Subject: Transmittal of Revision 2 to Service Bulletin Number  
V2500-ENG-72-0093

ENGINE - LP COMPRESSOR - REWORK THE NO.3 BEARING HOUSING ASSEMBLY  
TO INCORPORATE REVISED MATERIAL PINS

V2500-ENG-72-0093

Location of No.3 bearing housing assembly  
Figure 1

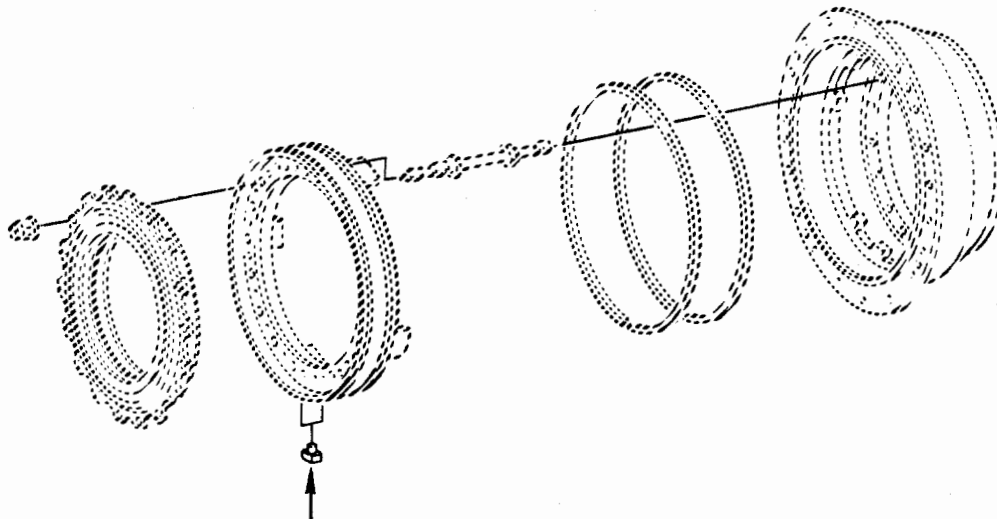
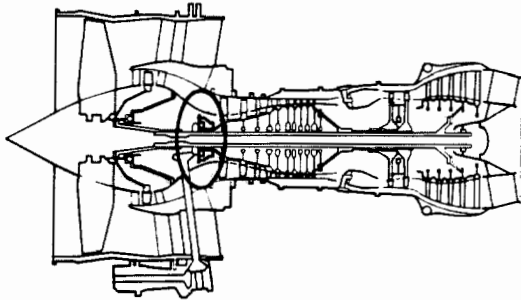
- (a) Remove the two 1A9666 Slab Pin from the No.3 Bearing Housing Assembly.
- (b) Install the new 2A2205 Slab Pin (2 off) in the No.3 Bearing Housing Assembly.

REPLACE PN 1A9666 SLAB PIN (2 Off)  
WITH PN 2A2205 SLAB PIN (2 Off)

Modification of the No.3 bearing housing assembly  
Figure 2

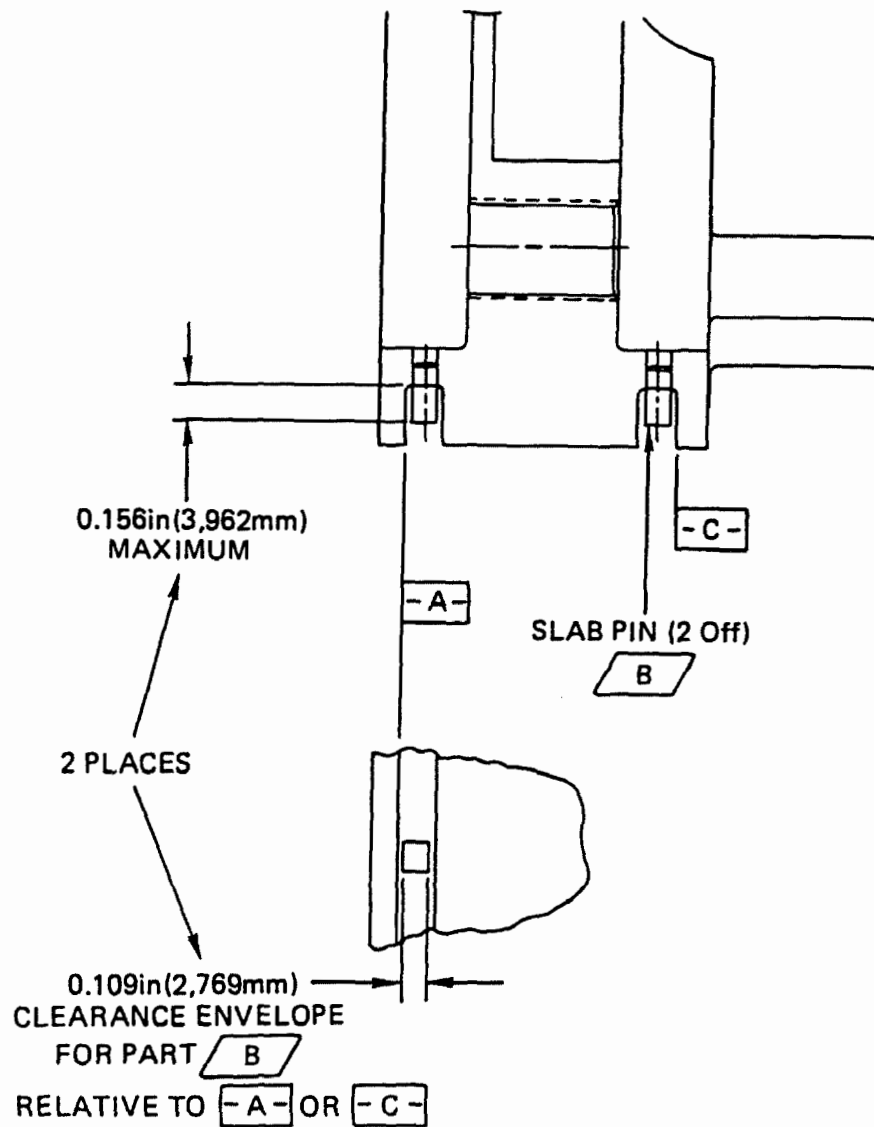
Refer to Figure 2 requirements. Use the IAE 3P16280 Holding Fixture or equivalent and IAE 3P16281 Pin Driver. Use the IAE 3P16282 Template Gage or equivalent to inspect the pin clearance envelope. Use the IAE 3P16283 Template Gage or equivalent to inspect the Pin height.

Family tree - No.3 bearing housing assembly  
Figure 3

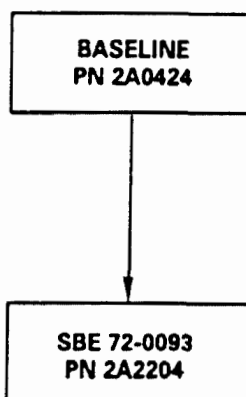
New Part No. (ATA No.)	Qty.	Est'd Unit Price (\$)	Keyword	Old Part No. (IPC No.)	Instructions Disposition
2A2204 (72-32-21)	1	6438.00	Housing Assembly, No.3 Bearing	2A0424 (01-020)	(S1) (1D) (A) (B)
2A2205 (72-32-21)	2	26.70	.Pin, Slab	1A9666 (01-040)	(S1) (A) (B)
